**RE: Palomas Peak Phase 2
Grading and Drainage Plan
Engineer's Stamp Date: 02/09/21
Hydrology File: D19D031**

Based upon the information provided in your submittal received 02/10/2021, the Grading and Drainage Plan **is not** approved for action by the DRB for Site Plan for Building Permit. The following comments need to be addressed for approval of the above referenced project:

PALOMAS PEAK
LOTS 12 AND 13, 8301 PALOMAS AVENUE
GRADING & DRAINAGE PLAN

1 SECTION AT PROPERTY LINE
Scale: 1"=5'

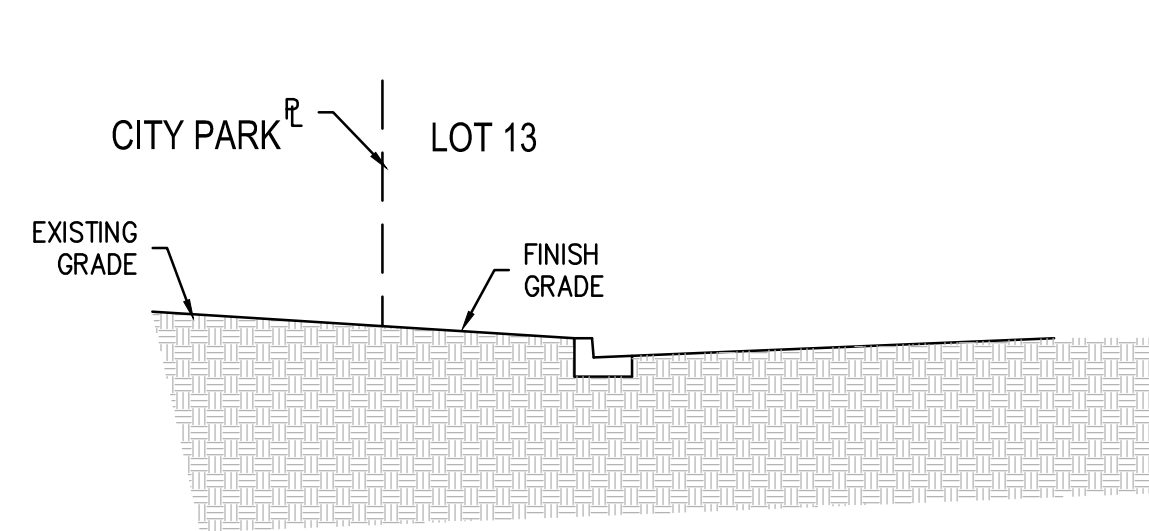
7. Sheet 2. Section 1. This section seems to be incomplete. It really seems irrelevant as shown. Please fix or delete.
8. Sheet 2. Pond Detail 4. Please flip the section arrow for Section 6, since it should be facing the retaining wall.

5 CMU WALL SECTION
Scale: 1"=5'

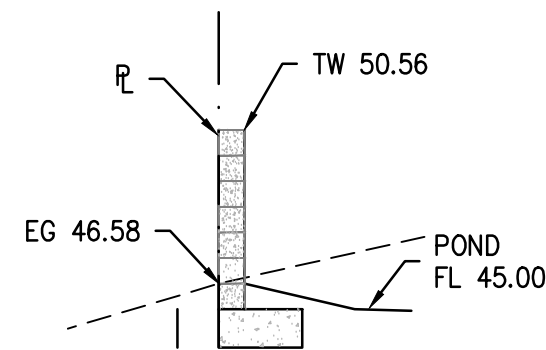
9. Sheet 2. Section 5. This section is incorrect. The section needs to not only show the existing retaining wall built in Phase 1, but the extension of that wall here in Phase 2, the bottom of the detention pond, the proposed retaining wall (Section 7), and the 100 year – 24 hr water surface elevation. Along with some horizontal dimensions.

6 CMU WALL ELEVATION
Scale: 1"=5'

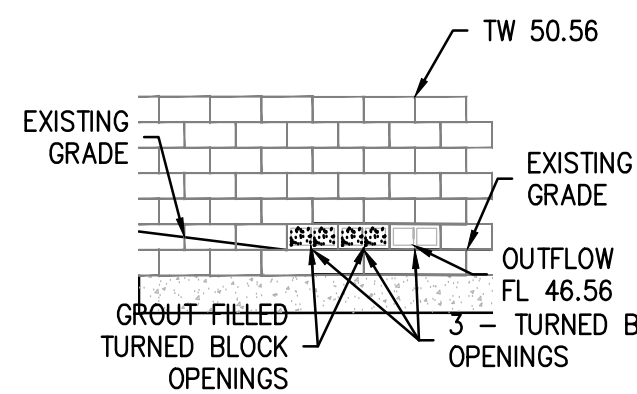
10. Sheet 2. Section 6. Please show the existing section of retaining wall that was built with Phase 1 and a new built portion since you are extending the wall up.

6 PCC POND WALL SECTION
Scale: 1"=5'

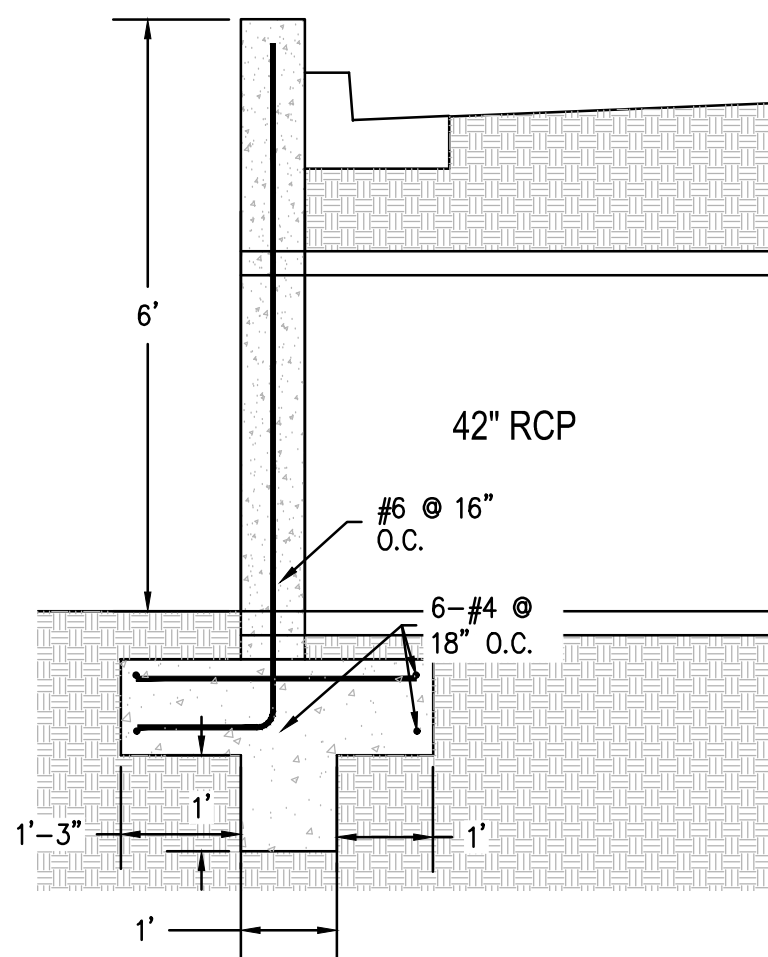
11. Sheet 2. Section 7. Please correct the section label. Also, please show the 36-in storm sewer in the sections since it appears to be installed right up against the retaining wall.

12. Sheet 2. Section 7. Please correct the section label.
13. Sheet 2. Please add a detail showing how the two inlets with the 36-in storm pipe system is connecting to the detention pond.
